Carolina Power & Light Company

OG-137  
Ref: OG-110,  
12/1/83 &  
OG-117  
3/9/84  
October 25, 1984

Westinghouse Owners Group  
Program to Address Generic Letter 83-10 - RCP Trip  
Response to NRC Questions

Figure 18 - Feedwater Flow (Ruptured + Intact Loop) (LBM/SEC)

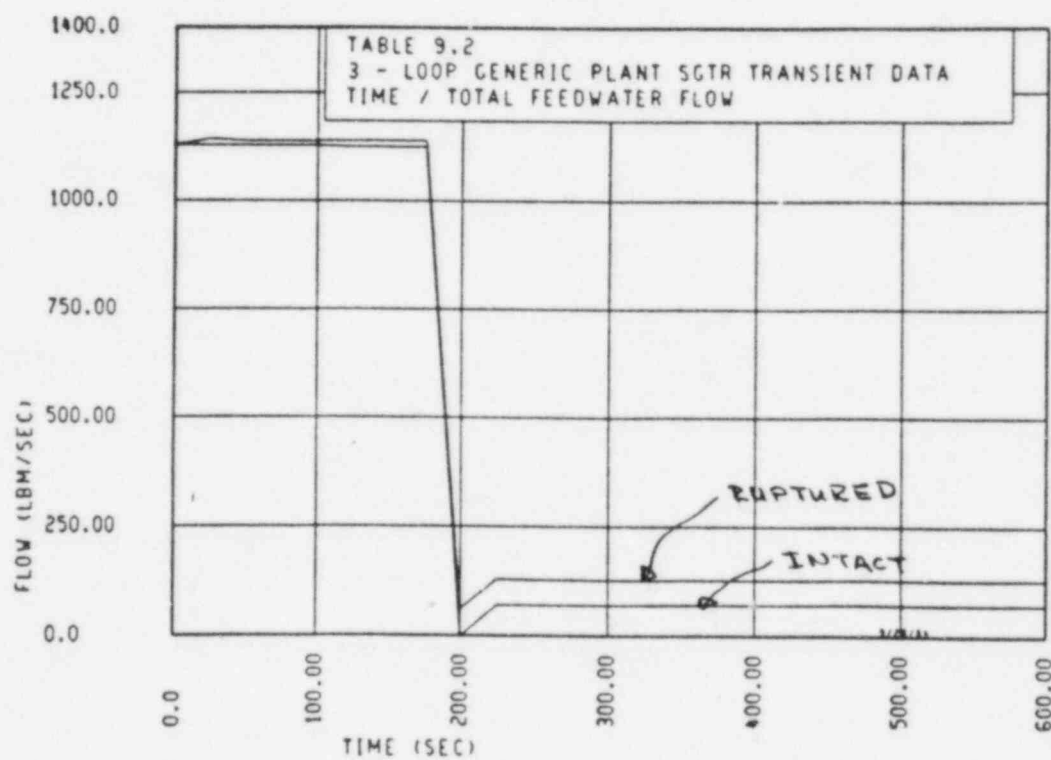
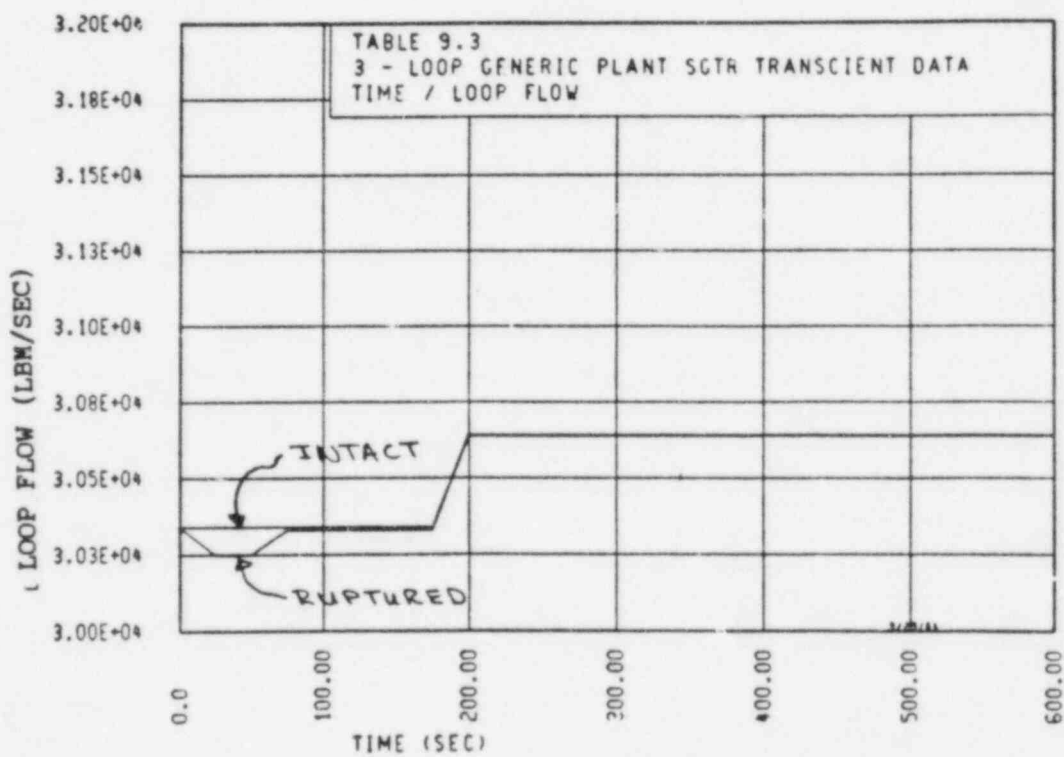
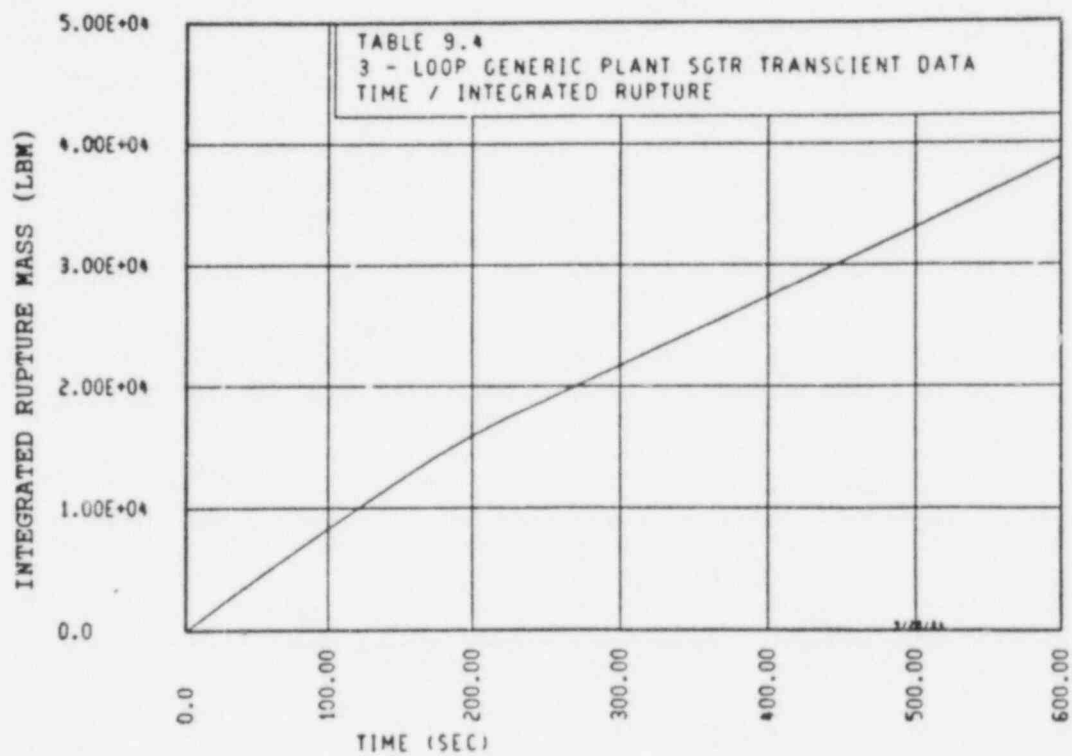
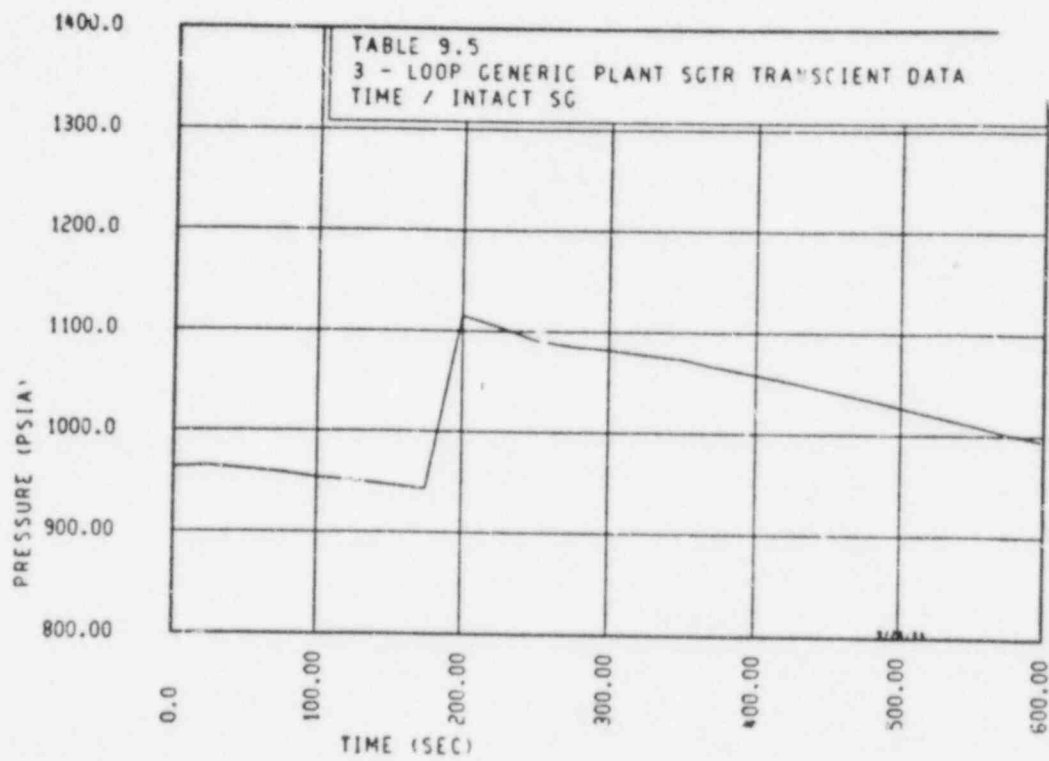
Q.73 We will be performing independent, confirmatory analyses of selected SBLOCAs and SGRs. In order to benchmark our calculations, please provide plots of the following parameters for the 3-loop generic PWR, for the 3.3 inch diameter SBLOCA and for the design base SGTR (where noted (\*)) these data were presented in the submittals for the SBLOCA case, .

- 1) RCS pressure - Figure 1
- 2) Secondary side pressure, ruptured - Figure 2  
Secondary side pressure, intact - Figure 21
- 3) Hot leg and cold leg temperatures, ruptured - Figure 3  
Hot leg and cold leg temperatures, intact - Figure 4
- 4) Core mixture level - Not applicable
- 5) SGTR rupture mass flow rate - Figure 3L Case 3 of Ref. 3
- 6) Integrated SGTR rupture mass flow rate - Figure 20
- 7) Hot rod temperature - Not applicable
- 8) RCS loop mass flow rate, ruptured - Figure 19  
RCS loop mass flow rate, intact - Figure 19
- 9) Steam flow rate, ruptured - Figure 5  
Steam flow rate, intact - Figure 6  
Total feedwater flow rate, ruptured - Figure 18  
Total feedwater flow rate, intact - Figure 18
- (10) Total Safety injection mass flow rate - Figure 17

The following pages contain the requested information in the form of graphs where applicable. It should be noted that only one figure is provided for Hot Leg Fluid Temperature, Cold Leg Fluid Temperature and Steam Generator Pressure. This is due to the fact that the variances in temperature and pressure for the figures would be imperceivable between the broken and intact loops, therefore, only one figure was provided.
